# UNITED STATES PATENT AND TRADEMARK OFFICE

10/773,016

<b>Office Action Summary</b>	Application No. 10/773,016	Applicant(s) ANDERSON, R. DAVID	
	Examiner Gene L. Bankhead	Art Unit 3744

## **DETAILED ACTION**

### Figure 5 (Longardner)

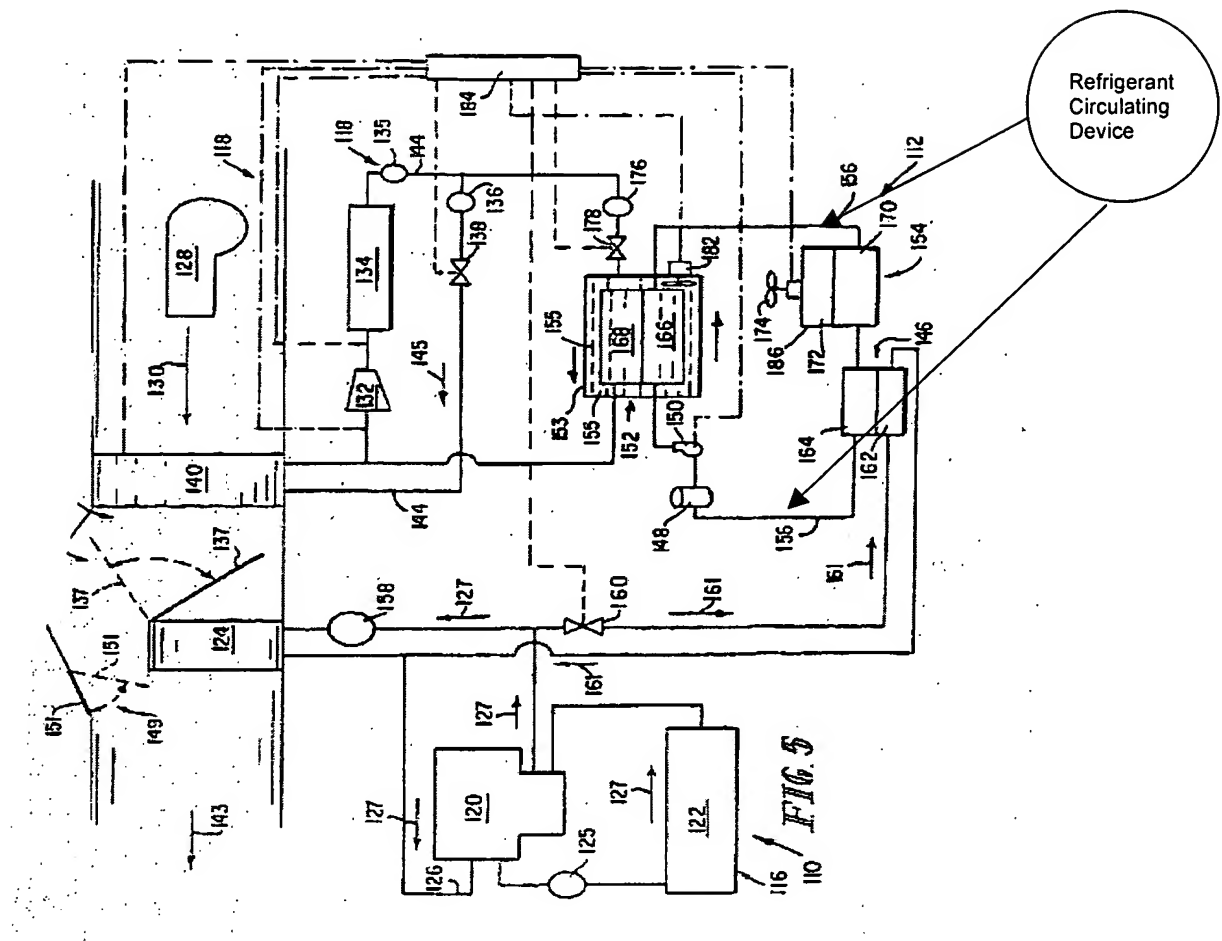
Claims 1,2,8-10,15-19, 24 and 25 are rejected under 35 U.S.C. 102(b) as being anticipated by Longardner (US 5553662). Longardner discloses a thermal energy storage system connected to an air conditioning system. The system comprises a compressor 132 capable of compressing a refrigerant, a condenser 134 connected to the compressor (see Figure 5), an expansion valve 136 and an evaporator unit 140 in heat exchange relationship with an air stream (column 11 lines 10-23). Longardner further discloses a thermal energy storage unit 112 with a tank 152 having a storage medium and an associated heat exchanger 146 between the condenser and evaporator (column 12 lines 29-37). Longardner further teaches a refrigerant circulating device 156, capable of circulating refrigerant through the heat exchanger, between the tank, condenser and evaporator (column 12 lines 29-37, 62-68 and column 13 lines 1-10 and Figure 5). The refrigerant circulating device includes a prime mover 150 and an auxiliary liquid (column 12 lines 40-44 and Figure 5), with the force of the prime mover exerted on the auxiliary liquid being indirectly transferred to the refrigerant (column 12 lines 45-68 and column 13 lines 1-10).

In regards to claim 9, Longardner teaches all limitations of claim 1. He further discloses a second temporary thermal energy storage tank 154, as recited in claim 9 line 30. Longardner discloses a valve system, 138 and 178, capable of controlling the flow of refrigerant through the system. The valve system is capable of operating to provide the three distinct time periods, as disclosed in claim 9:

Figure 6 (Clark Jr.)

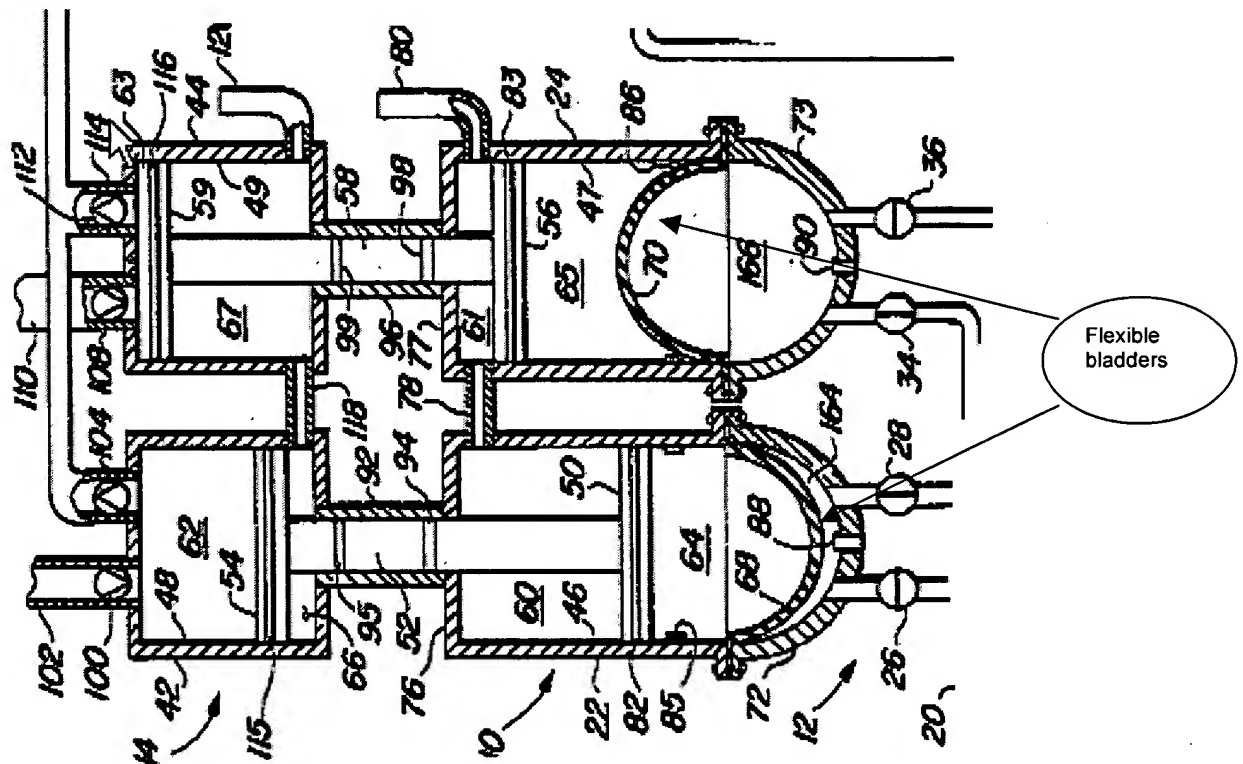
Regarding claims 5, 12, and 21. Claim 5 differs from Longardner in calling for a prime mover mechanically coupled with fluid cylinders to circulate the refrigerant. Longardner teaches a prime mover 150 mechanically coupled to an engine 120 (column 10 lines 42-56 and column 12 lines 29-68 and column 13 lines 1-10). Longardner teaches most limitations of claim 5, however does not disclose a pair of fluid cylinders communicating with a prime mover. Clark Jr. discloses a thermally powered engine 10 with two fluid cylinders 22, and 24. Longardner teaches a thermal storage system 112, connected to an air conditioning system, coupled to an engine 120 via an engine coolant loop system 116 (column 10 lines 42-56 and column 12 lines 29-68 and column 13 lines 1-10). Modifying the engine of Longardner with the engine of Clark Jr. enables the prime mover 150 of Longardner to be coupled with the pistons 50 and 56 of cylinders 22 and 24 of the Clark Jr. engine during the pump's 150 operation (column 10 lines 42-56 and column 12 lines 29-68 and column 13 lines 1-10). At the time of the invention it would have been obvious to one of ordinary skill in the art to modify the engine of Longardner with Clark Jr. because coupling piston's with the prime mover greatly increases the amount of work done on the refrigerant being circulated. Simple fluid mechanics teaches the amount of work done on the refrigerant due to the prime mover acting alone is far less than the amount of work done on the refrigerant when the prime mover is coupled with a hydraulic cylinder with fluid. Clark Jr. does not specify oil as the fluid used in the cylinders. It would have been obvious to one of ordinary skill in the art to use oil, as it well known in the art that oil is incompressible and thus increases the efficiency of the hydraulic cylinder.

Regarding claims 6,13 and 22 Clark Jr. further teaches flexible bladders 68 and 70 located within each of the fluid cylinders, see Figure 6.
